HISTORIC PRESERVATION COMMISSION

APRIL 22, 2021

PLANNING AND INSPECTIONS DEPARTMENT STAFF REPORT

To: Historic Preservation Commission
From: Peter Hughes, Senior Planner
CC: Darryn Burich, Planning and Inspections Director
Kelly Brown, Administrative Specialist
Date: April 12, 2021
Subject: Major COA Request for 1 Carolina Vista (future address to be determined)

EXHIBIT G

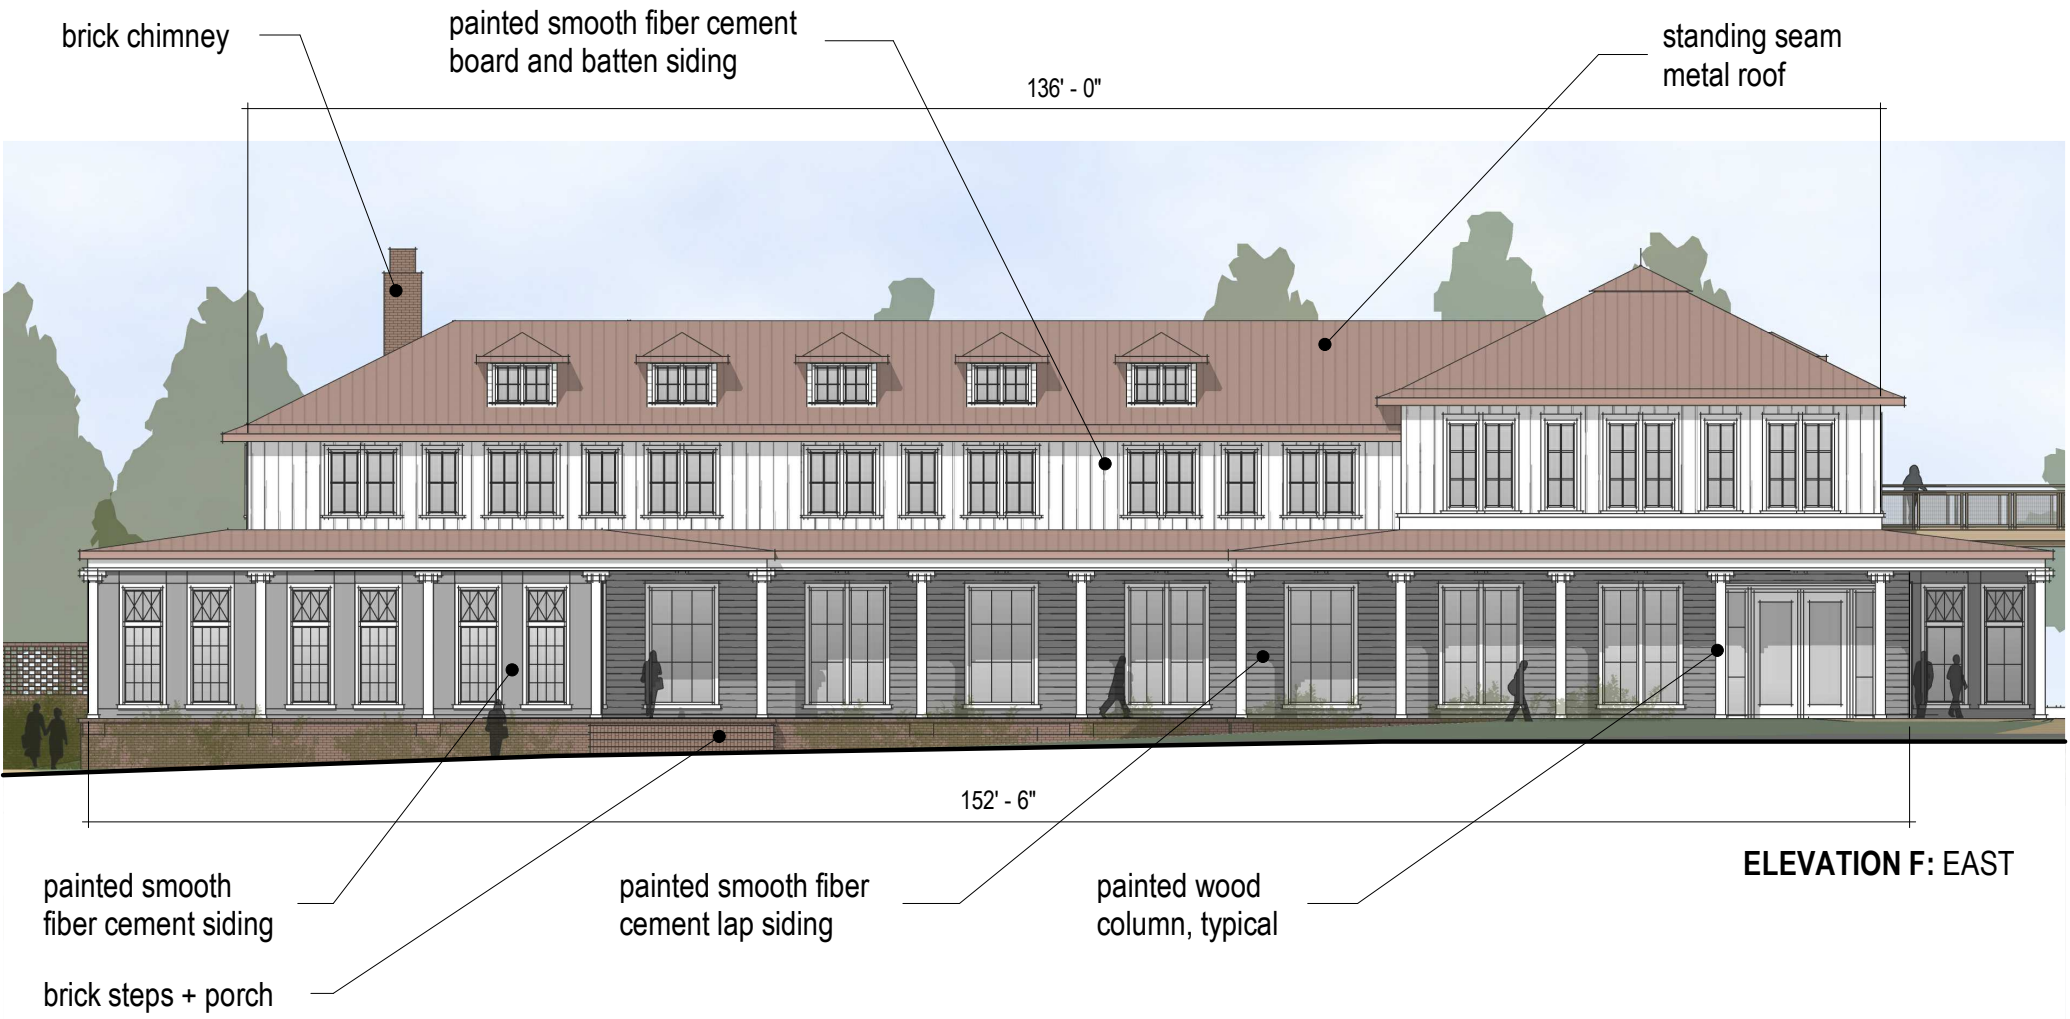
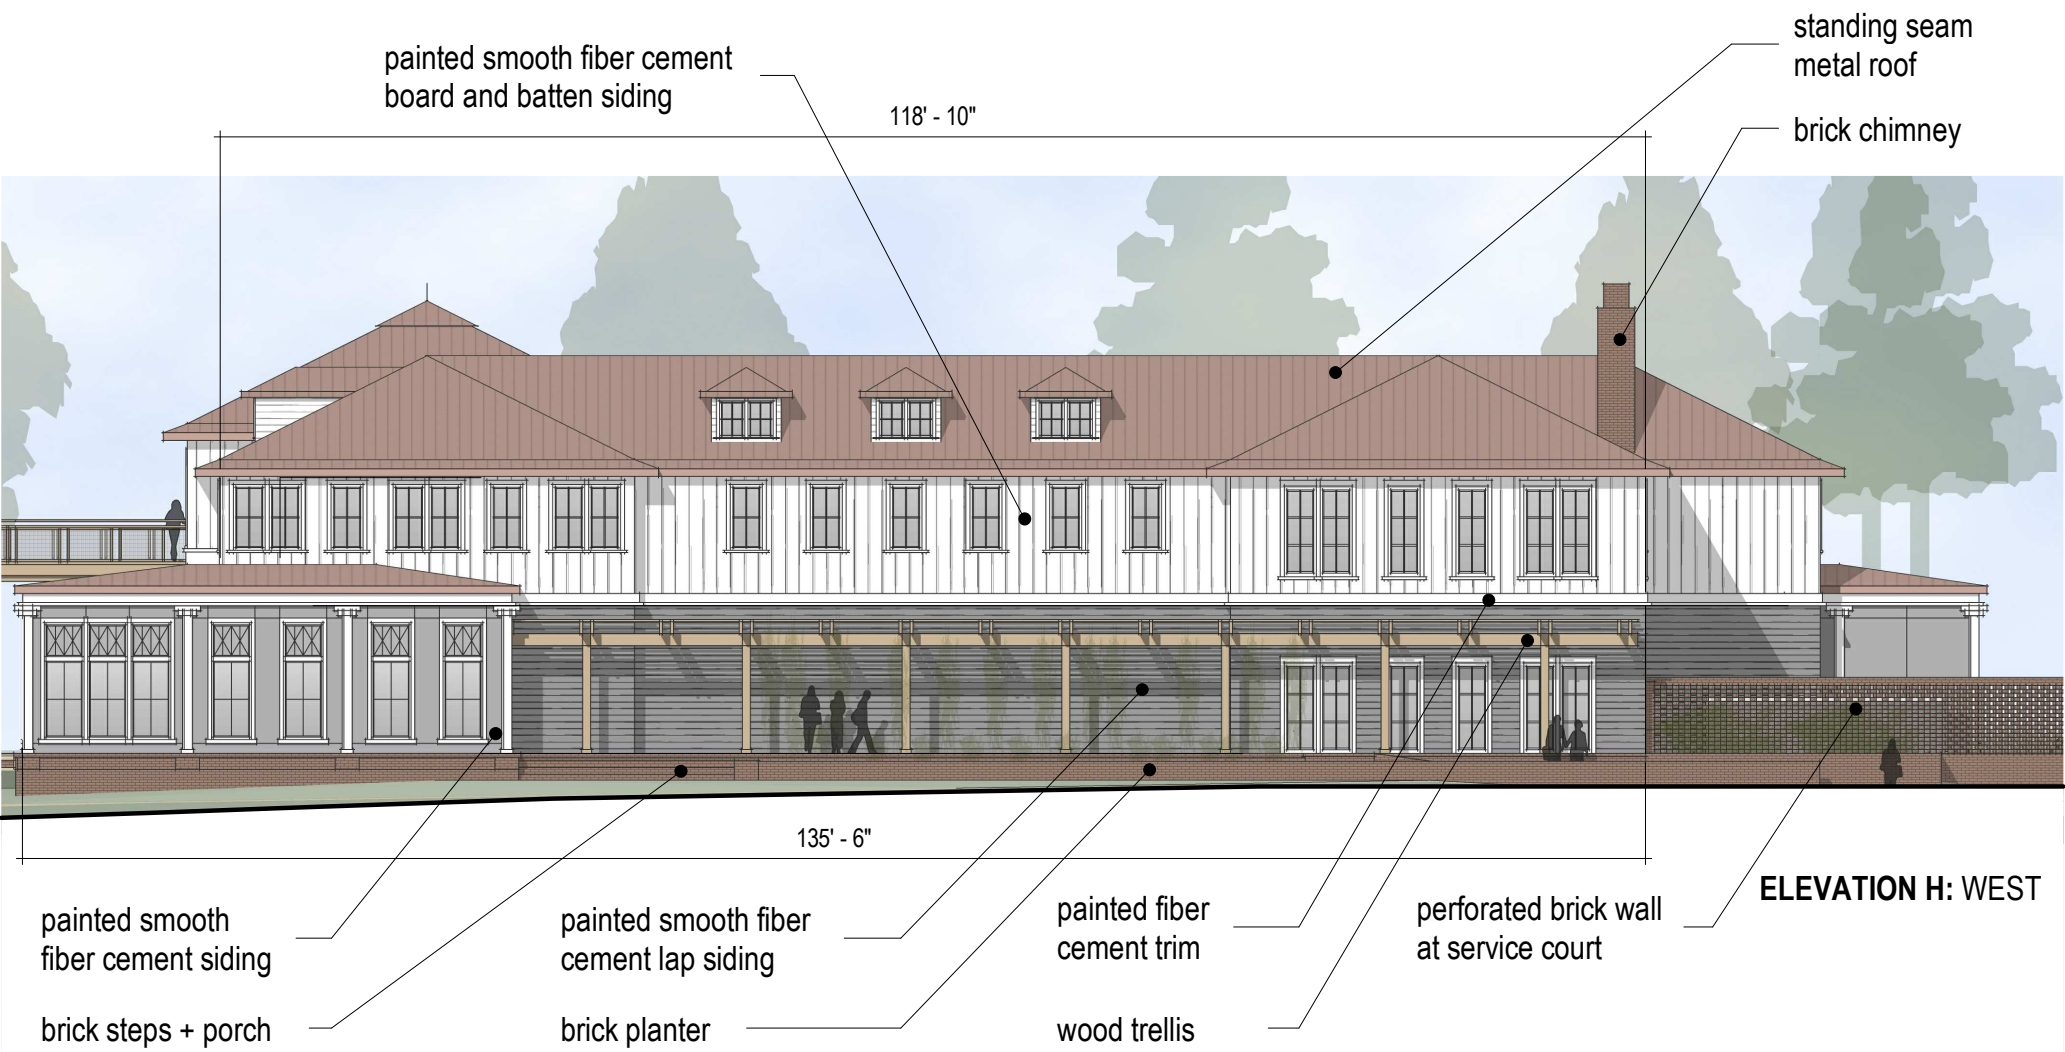
The elevations indicate that the main USGA building will feature dormers. Dormer windows are featured on multiple commercial structures, throughout the Historic District such as the Harvard Building and Holly Inn. The inclusion of dormers on the USGA assists with wayfinding and establishes a unique architectural detail that helps distinguish the two structures from one another.

The applicant is proposing construction of a two story walk way that connects the USGA building with the Museum structure. This architectural detail would be a distinct characteristic to the site and would be a unique design element within the Historic District.
